**TO:** Kristopher Apanian, TAIT & Associates, Inc.  
**FROM:** Amber Wood Hicken, Planner I  
**DATE:** 7/25/25  
**SUBJECT:** Parker Pointe, Auto Parts Store, Site Plan  
Review Comments 03

*Staff Comments 03*  
*SP25-025; Auto Parts Store*  
*Site Plan*  
*7/25/25*

PROJECT:  
NEW O'REILLY AUTO PARTS STORE  
STROH RD  
PARKER, CO #2

SITE PLAN COVER SHEET

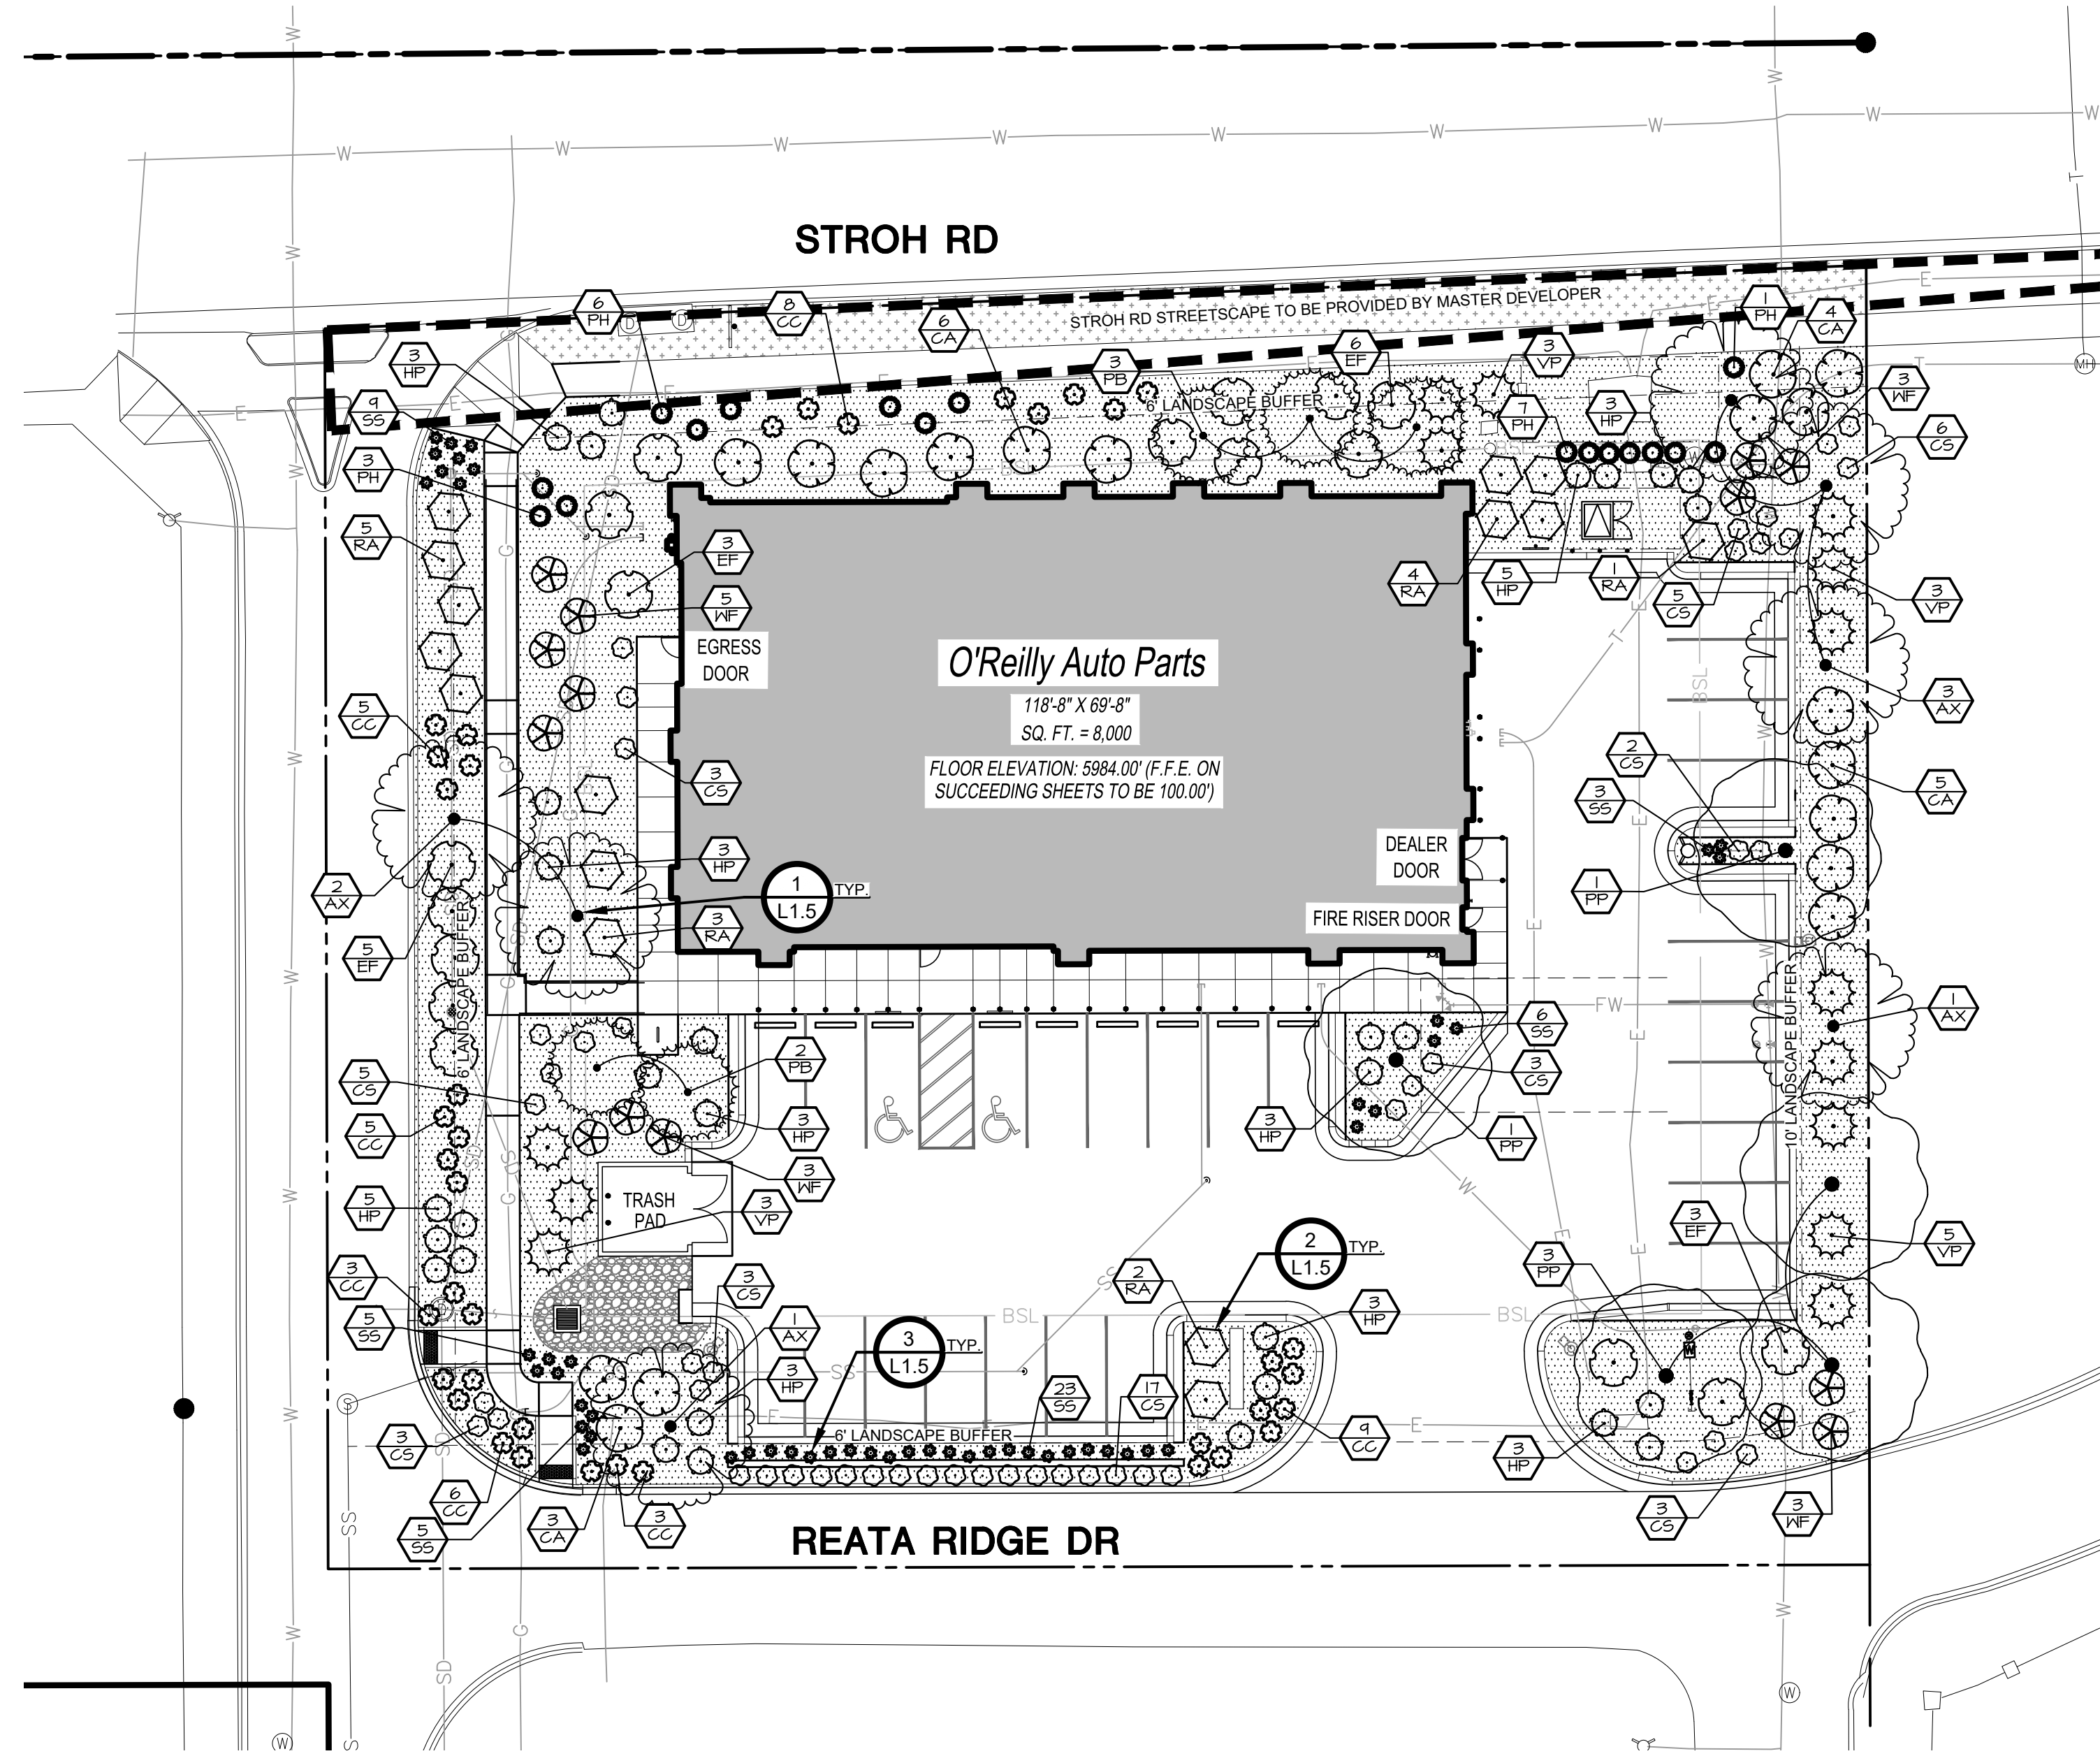
add zoning (Mixed-use Community)

TAIT Response: Added zoning to table

**1 LANDSCAPE PLAN**  
L1.0 SCALE: 1" = 20'-0"

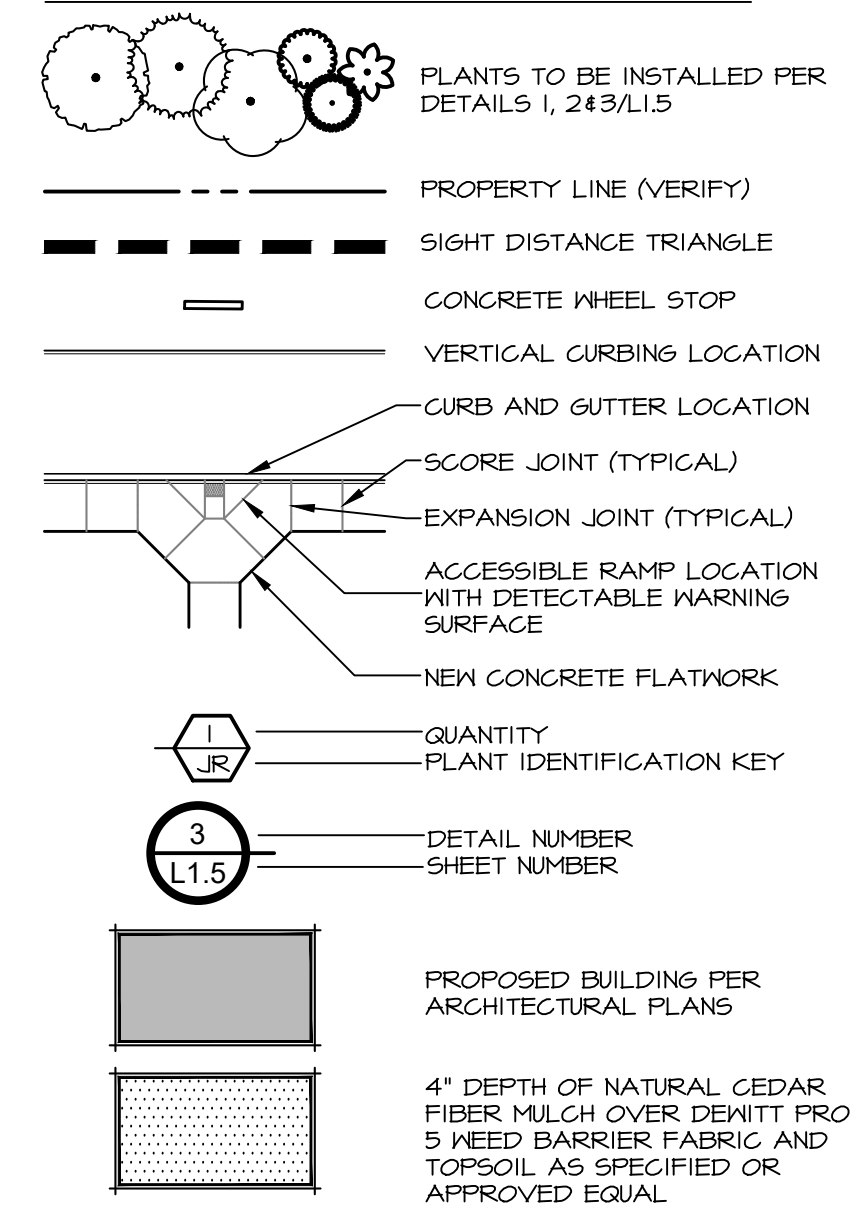
deciduous trees must be 2.5" caliper. ornamental trees must be 2" caliper. please note what type of trees are proposed and adjust caliper if necessary.

shrubs must be in 5-gal containers

Breckon Response: Revised tree sizes to be 2.5" CAL in size

Breckon Response: Revised shrub sizes to be 5 gallon in size

**SITE LIGHTING PHOTOMETRICS**  
SCALE: 1"=20'

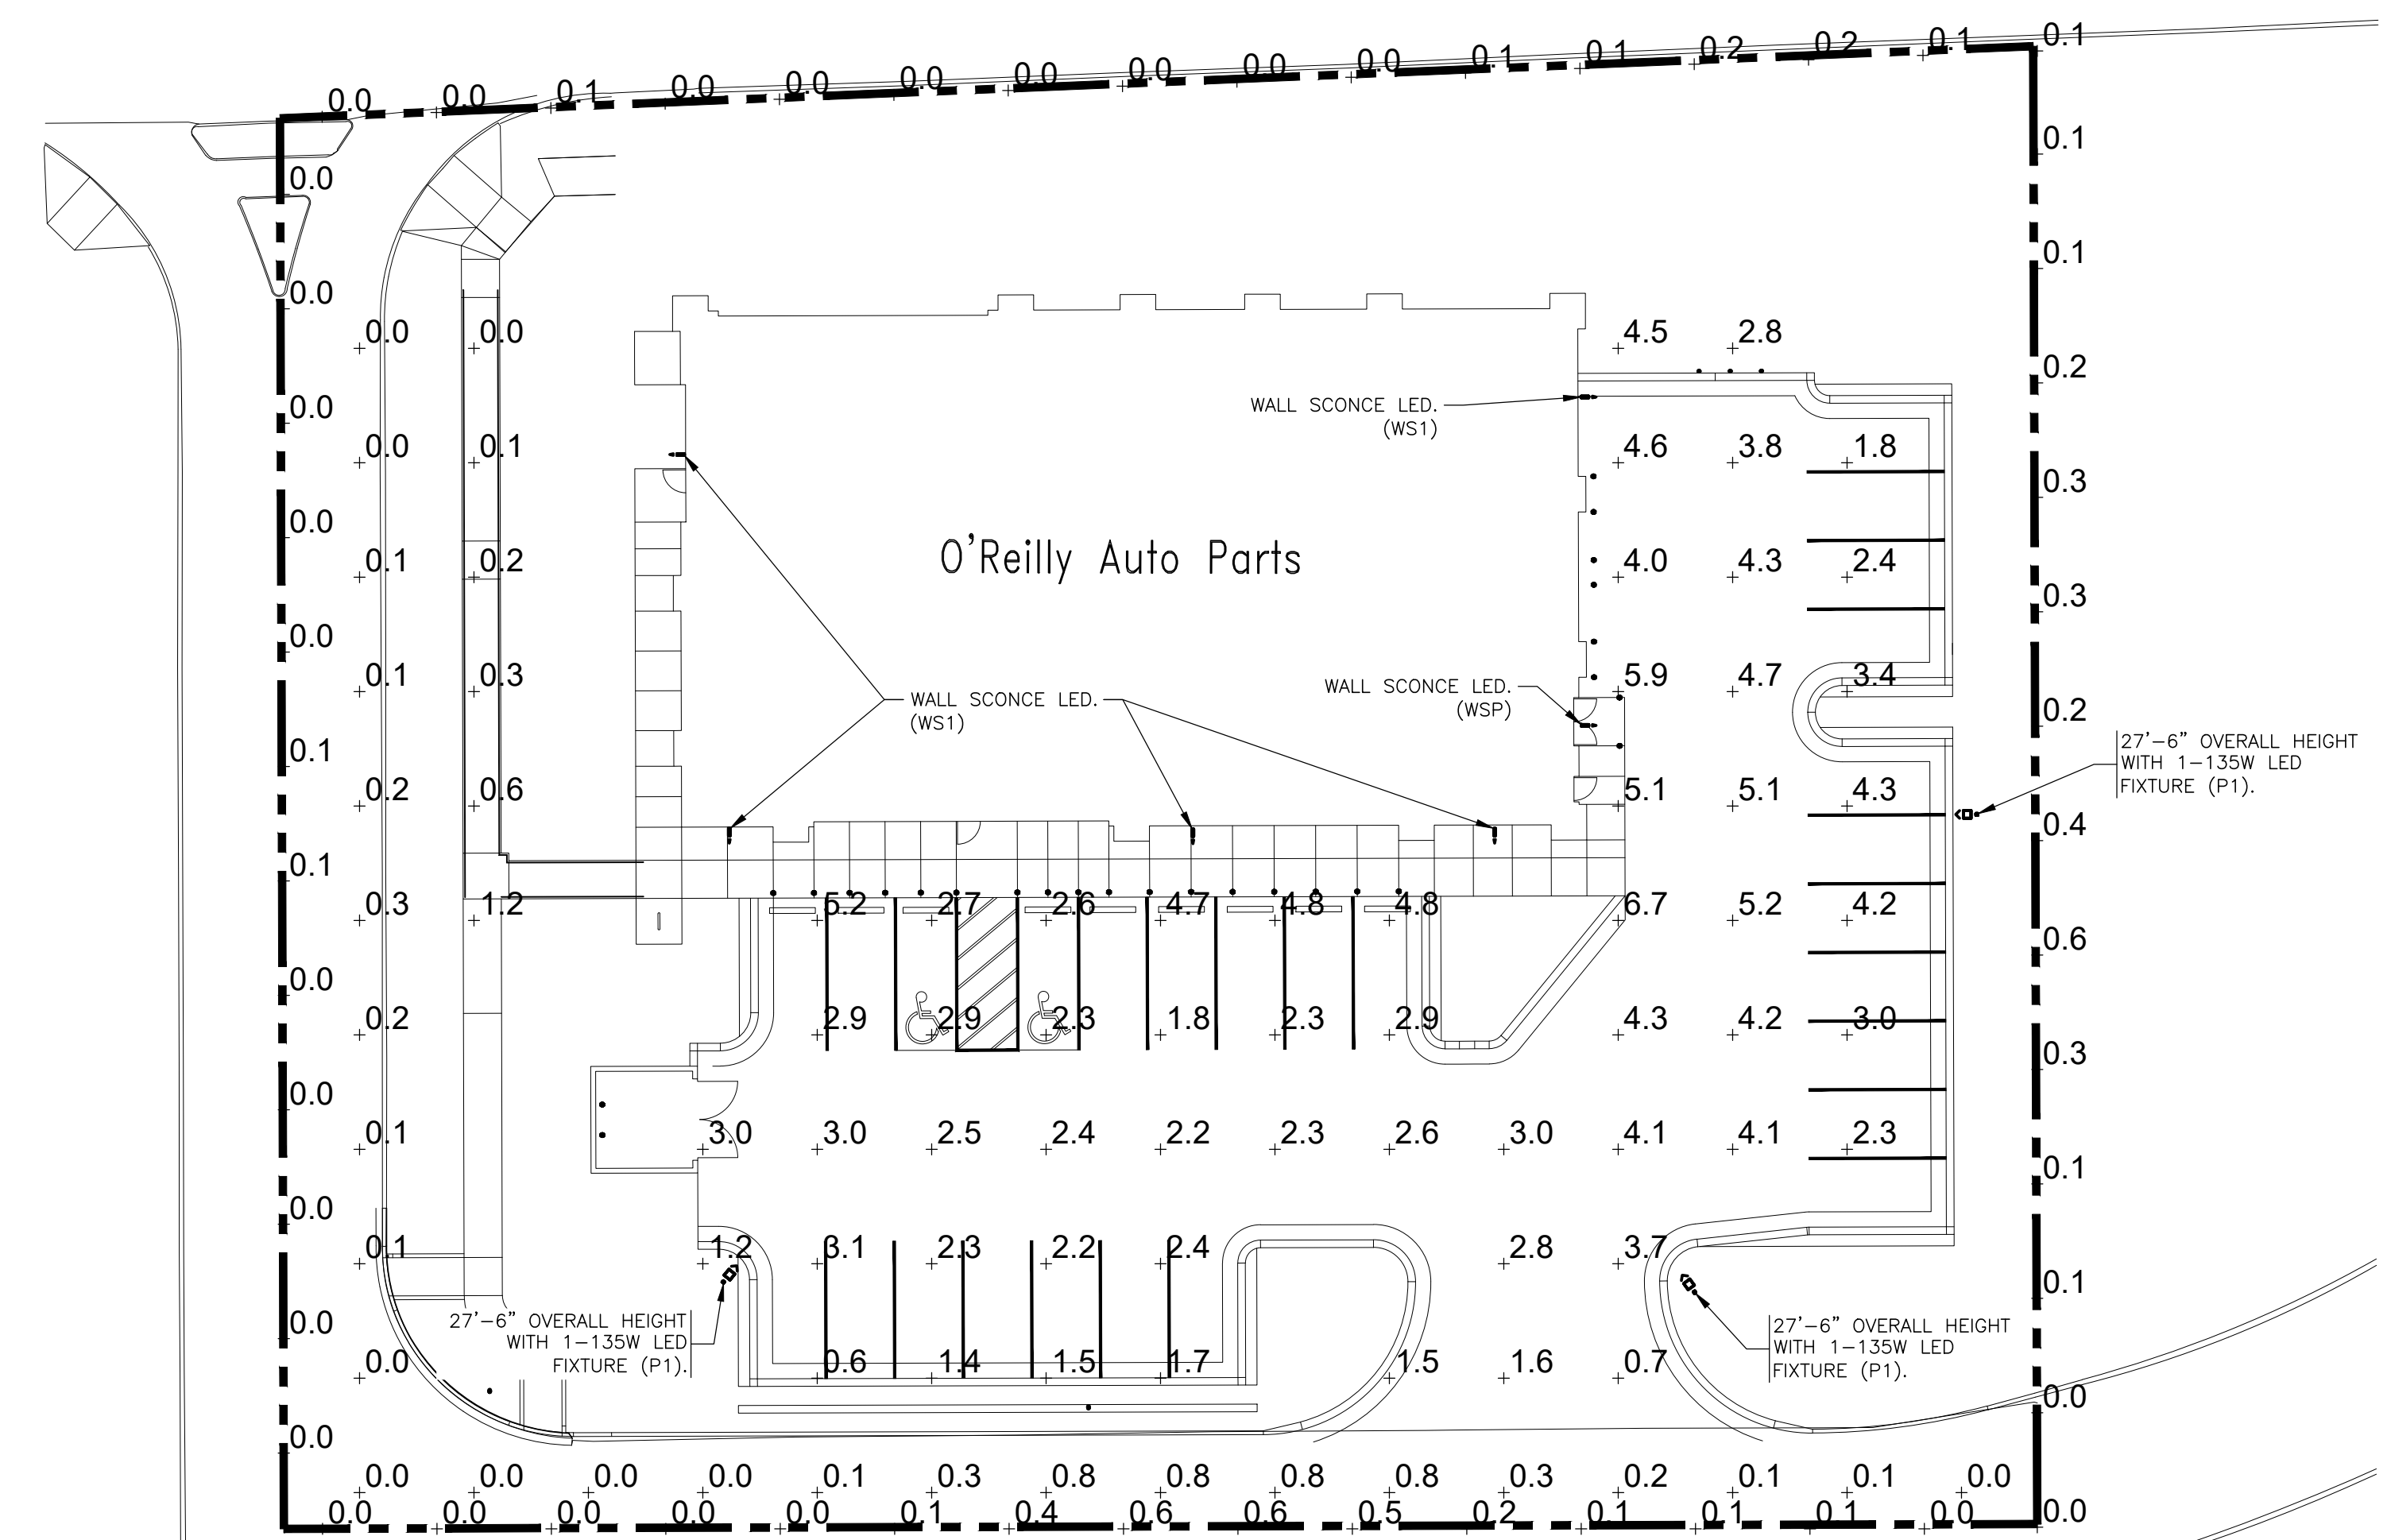
include quantities of each

include table for uniformity ratio for drive aisles and parking lot ( should be 6:1 max to min)

SGE Response: Please see Sheet SP1 in the Exterior Light Fixture Schedule table for fixture quantity

SGE Response: Please see Sheet SP1 for Statistics table for uniformity ratio for drive aisles and parking lot
